66105A-09A

SERVICE NOTE

66105A DC Power Supply

Serial Numbers: Serial Numbers: MY40001188/MY40001225

Figure 2

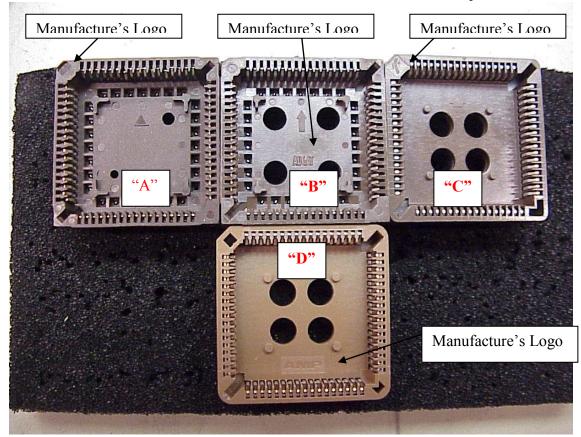
This figure should be used to identify **GOOD** sockets and a potential defective socket. The **16-Bit MCU 16 MHZ 68PLCC CMOS IC** (P/N 1821-1479) is <u>NOT</u> pictured.

Socket "A" is a sample of a GOOD AMP socket.

Socket "B" is a sample of a GOOD Tyco/Augit socket.

Socket "C" is a sample of a GOOD FCI socket.

Socket "D" is a sample of a DEFECTIVE Tyco socket.

The sockets above labeled "A","B" or "C are good and should NOT be replaced.

The socket above labeled "D" is considered defective should replaced.

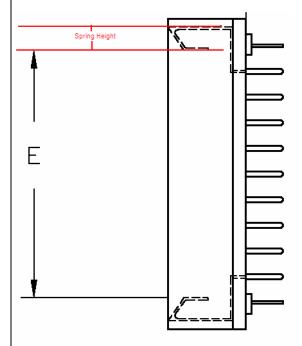
The information described in the following documents is the Corrective Action Plan from Tyco related to the 68 pin PLCC socket MFPN **1-822473-6**.

The condition of the recessed beams has been corrected by a design enhancement implemented in production. This design enhancement increased the spring height dimension by 0.04mm and decreased the spring height tolerance by 40%. The spring height dimension is shown in the drawing below.

This design enhancement is intended to position the contact beams closer to the middle of the socket and increase the normal force exerted on the contacts of the chips mated to the socket.
